JONES & BEACH ENGINEERS INC.

April 19, 2022

**RE: TAC Resubmission Letter
1169 and 1171 Sagamore Ave, Portsmouth, NH
Tax Map 224, Lots 14 & 15
JBE Project No. 21047**

Plan Name: **GRADING AND DRAINAGE PLAN**

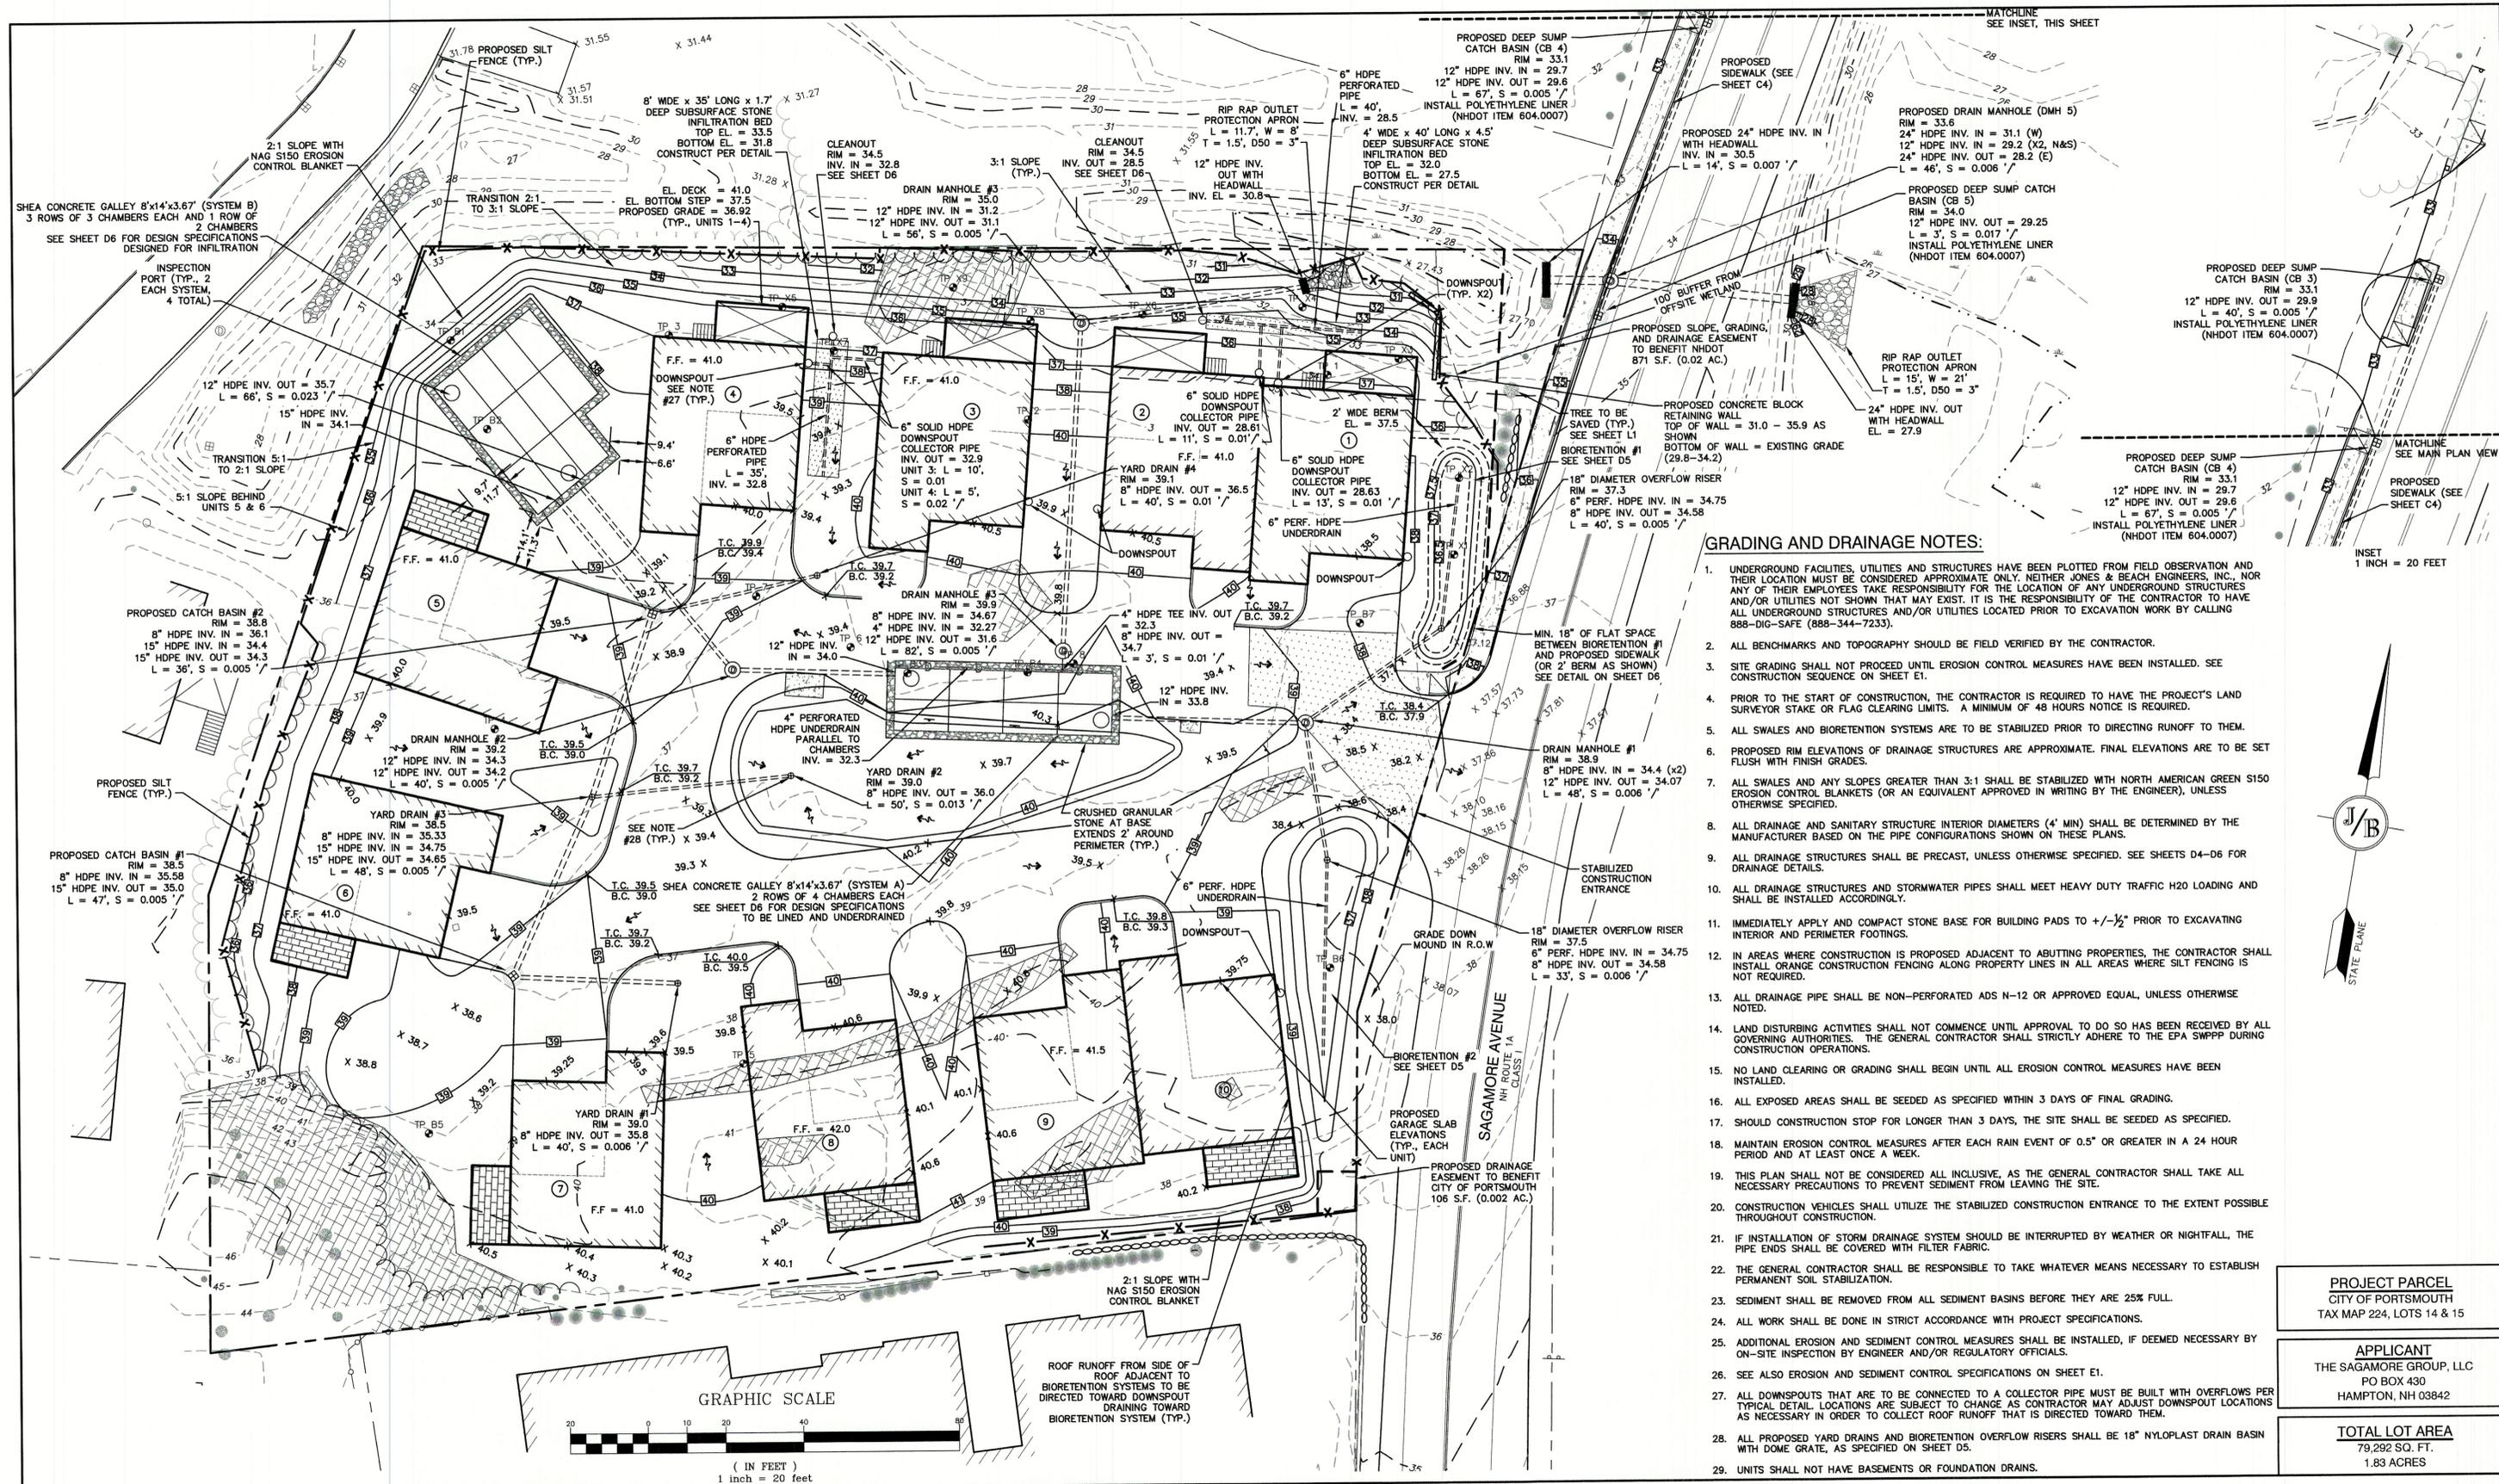
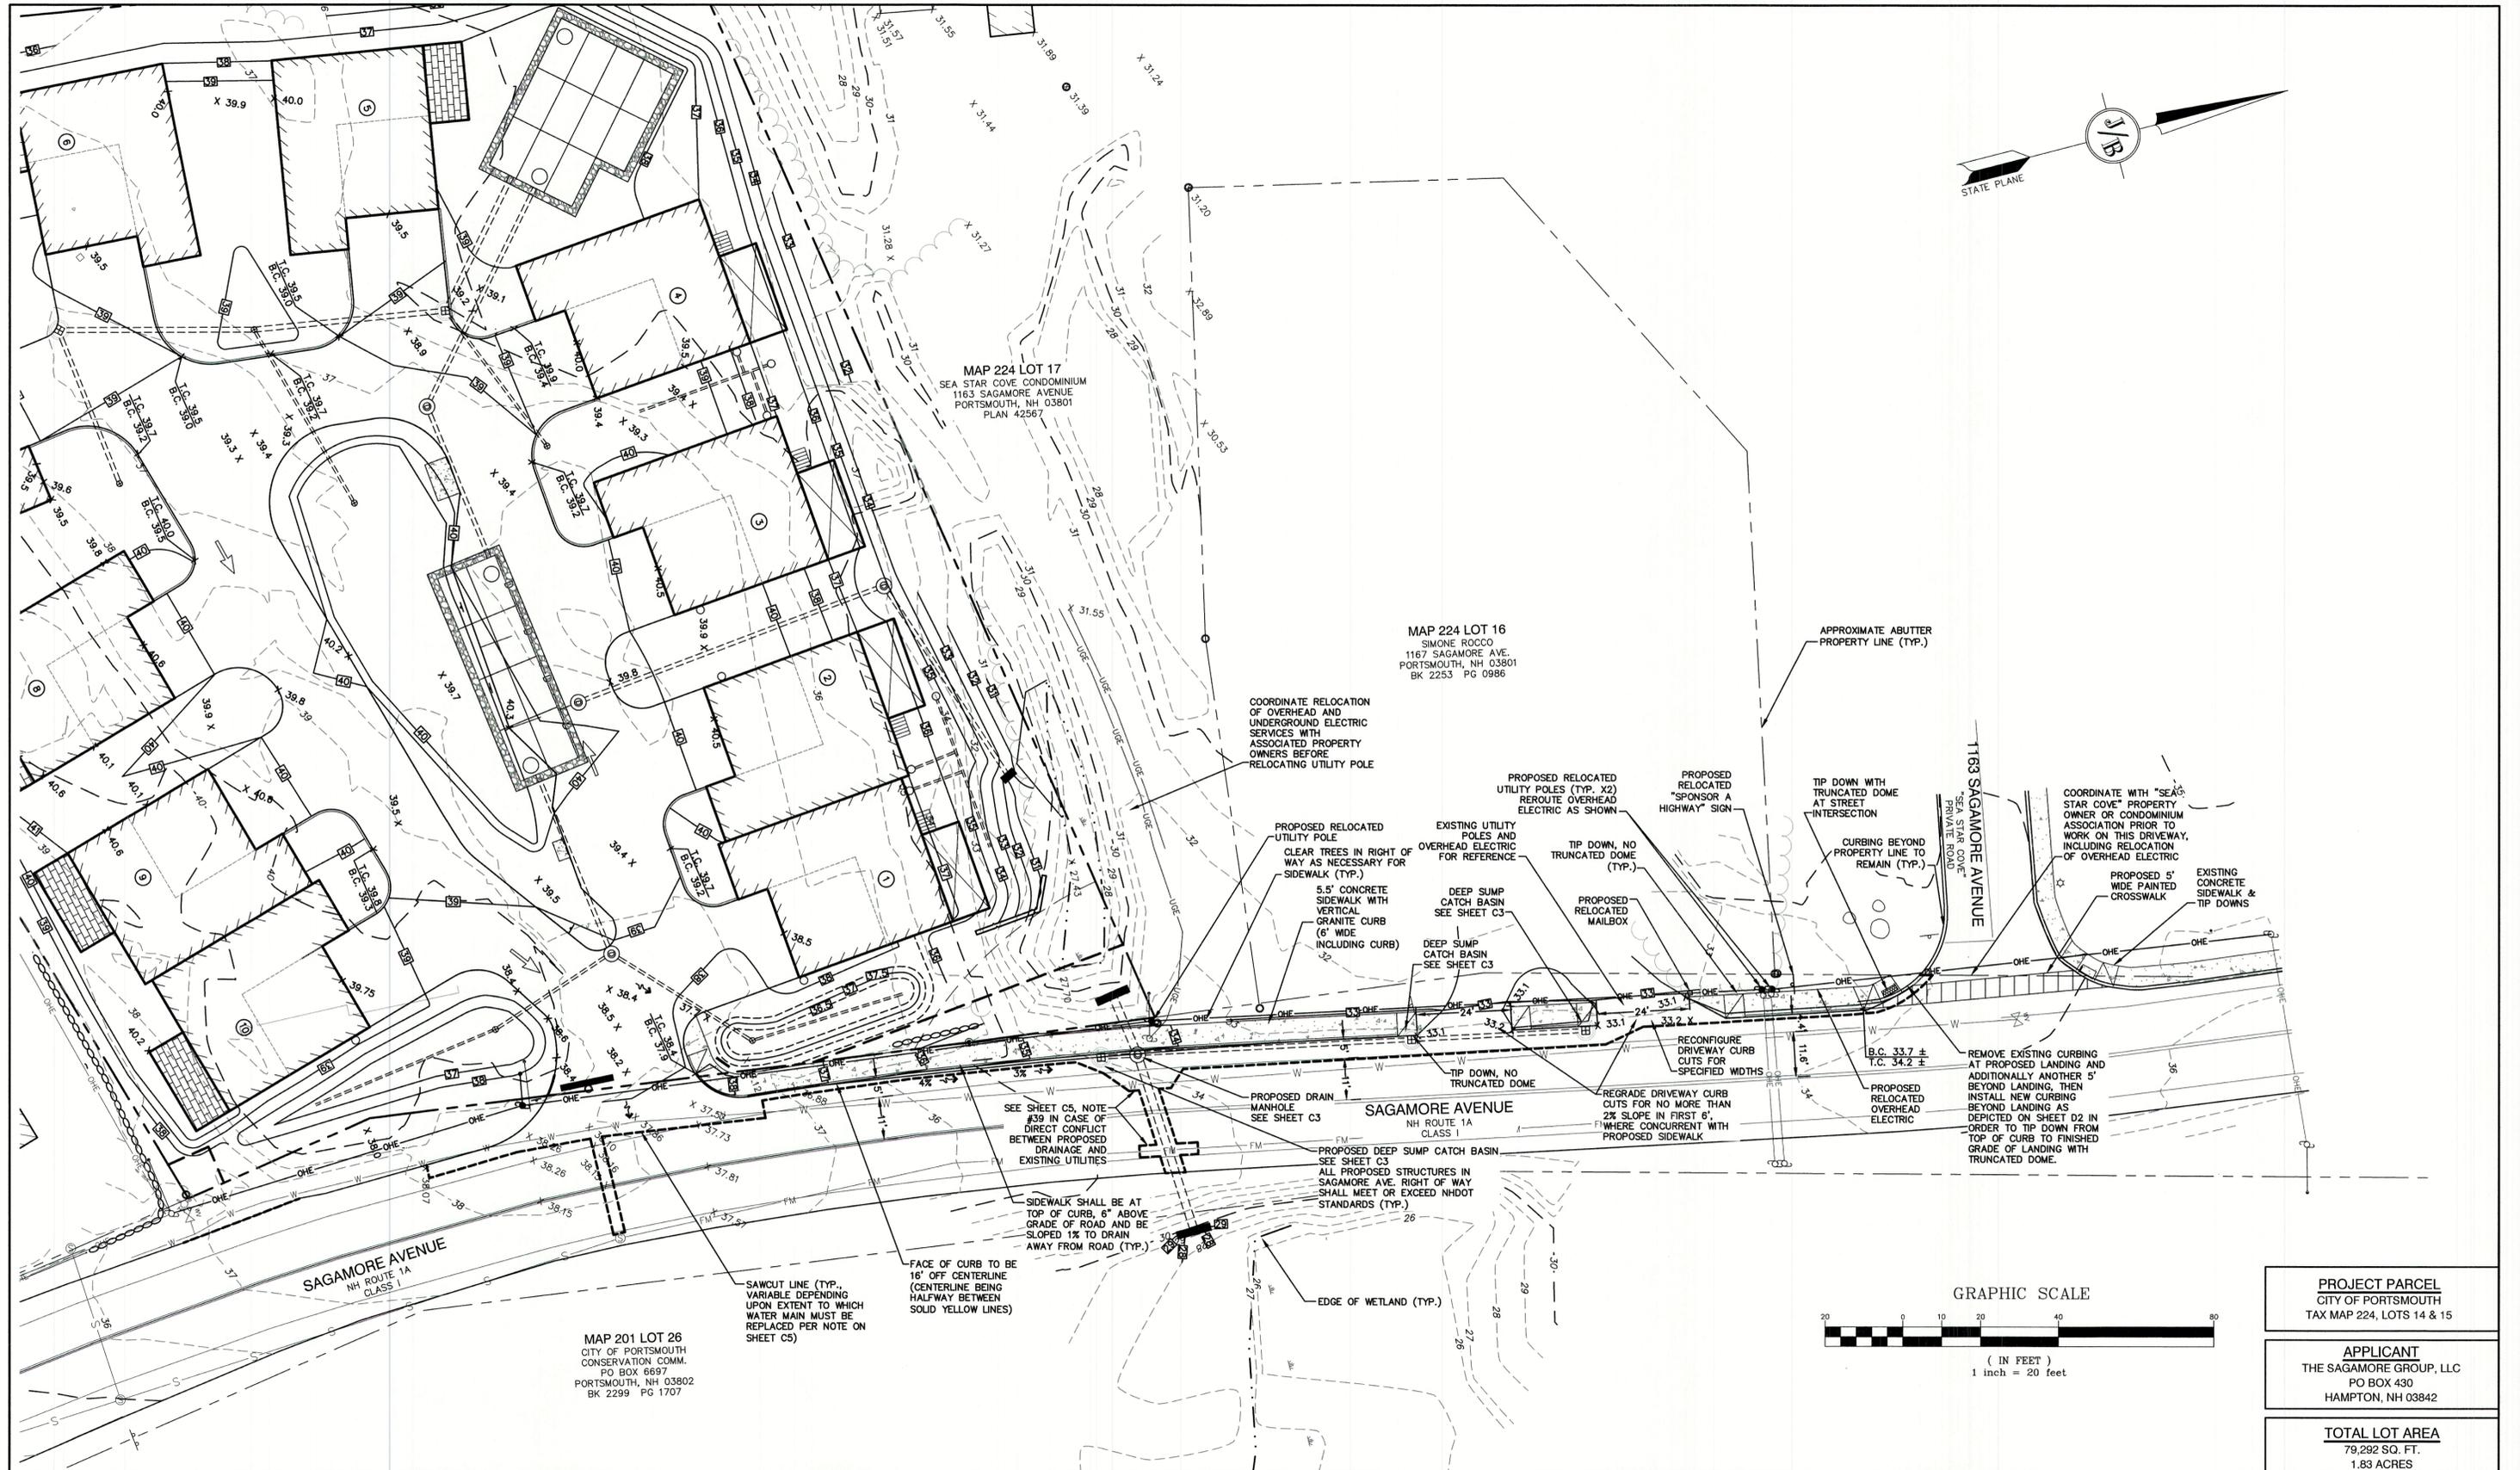
To further reduce the amount of drainage into the Sagamore Avenue right of way, it was requested that the mound in the southeast corner of the property near Unit 10 be regraded and shaped to extend the length of bioretention pond #2. This re-grading has been done as shown on Sheet C3.

Mr. Weinrieb suggested that the outlet from the detention chambers be moved closer to inlet of proposed cross-street culvert to reduce the potential for short-circuiting of the depression in the northeast corner of the property. The proposed outlet from the detention chambers has been relocated as suggested, as shown on Sheet C3.
